SUBJECT: Transmittal of Revised Responses to AP1000 DSER Open Items

**AP1000 Design Certification Review
Draft Safety Evaluation Report Open Item Non-Proprietary Responses**

DSER Open Item Number: 6.4-1 Revision 2

DSER Open Item Number: 15.3-1 Response Revision 3

Figure 1: MAAP4 Containment Temperature for Sequence 3BE-1

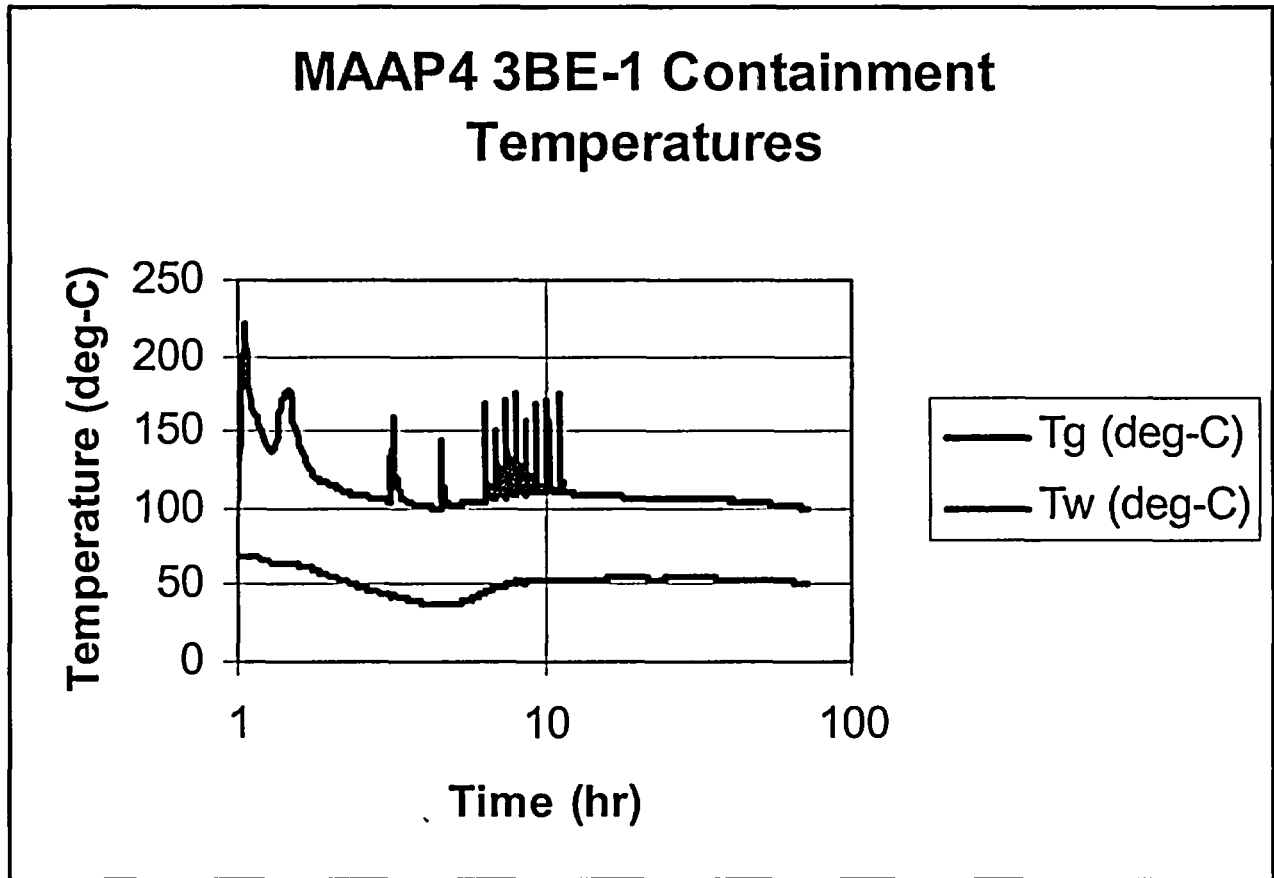
- a) Provide additional justification for aerosol removal by thermophoresis. In particular, address how the heat transfer rate from the air to the containment wall is calculated and applied in the determination of aerosol removal by thermophoresis.
- b) The particle density fraction (0.8) and void content (water) used by Westinghouse are not sufficiently conservative; NRC would agree with particle density fraction of 0.6 and void content of air.

Only convection heat transfer should be used in determining the lambda due to thermophoresis.

The convective heat transfer to the containment shell was determined from the MAAP4 simulation of sequence 3BE-01. The containment gas temperature and the film temperature on the wall are shown in Figure 1 for this sequence. Figure 2 shows the temperature difference between the gas and the film which is the driving mechanism for heat transfer. Figure 3 shows the MAAP4 calculated convective heat transfer to the film on the containment inner surface.

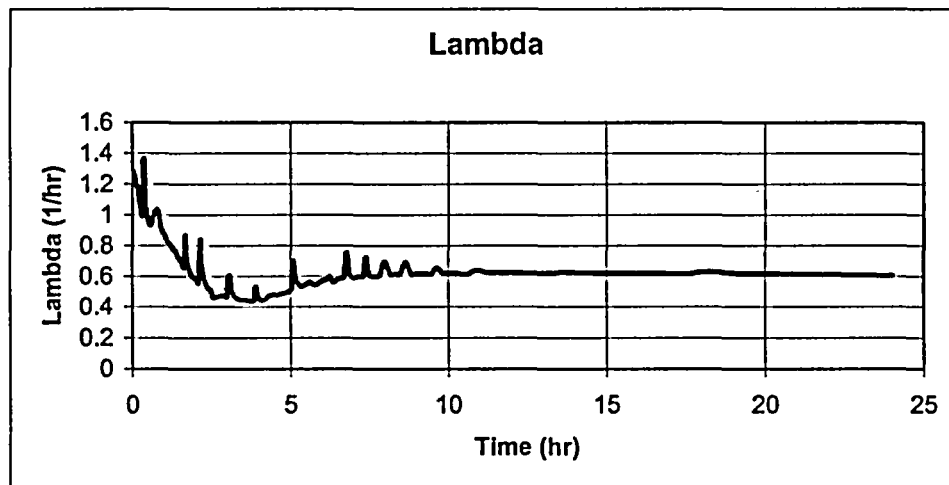
Explain the long term trend of the overall lambda for AP1000 as compared to that for AP600.

The overall aerosol removal coefficients (λ) calculated by STARNAUA are shown in the figure below. These removal coefficients are used in the LOCA dose analysis to determine the offsite and control room doses.

It is noted that the AP1000 overall λ decreases only slightly after about 7 hours out to 24 hours. For AP600 the overall λ decreased about 10% over this time period. This difference is assessed as follows.
